UNITED STATES PATENT AND TRADEMARK OFFICE

APPLICATION NO.	FILING DATE	FIRST NAMED INVENTOR	ATTORNEY DOCKET NO.	CONFIRMATION NO.
10/754,876	01/09/2004	Ronald A. Trumble	SLTRUM.00002	8670

Office Action Summary

DETAILED ACTION

Fig. 3

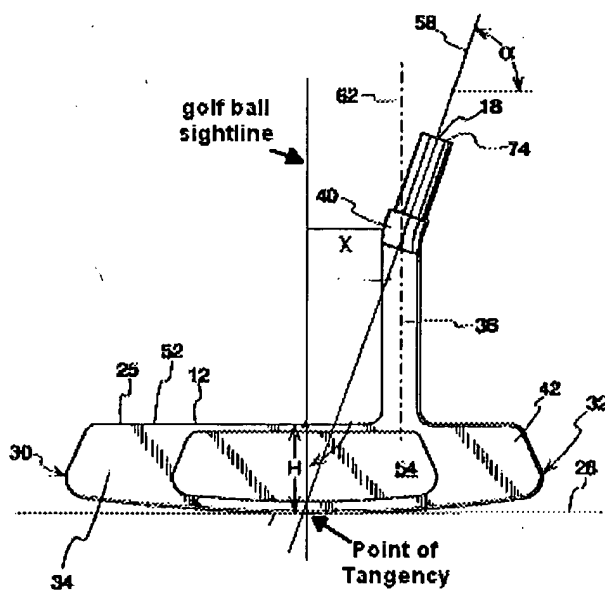
Regarding claim 1, Pinns shows a golf club having a shaft **14** for holding the putter, a putter head **12** affixed to a terminal end of the shaft, vertical leg **38**, horizontal leg **40**, and a stub shaft **18** wherein elements **38**, **40**, and **18** make up a shaft attachment means at the end of the putter head for receiving the terminal end of the shaft wherein a centerline extends through the center of the shaft and continues through

a center portion of the stub shaft (See Figures 4 and 5). Pinns does not explicitly disclose the shaft attachment means being a hosel. Klein discloses a golf putter having a hosel for connecting the shaft to the putter head (See Figures 4 and 5 and paragraph bridging columns 4 and 5). The hosel of Klien has a stub at the end thereof and is recognized to be a hosel; therefore, it is submitted that Pinns inherently shows a hosel for receiving a shaft.

Regarding claim 2, Pinns shows the hosel allowing the putter head to be recessed relative to the centerline of the putter (See Figure 4).
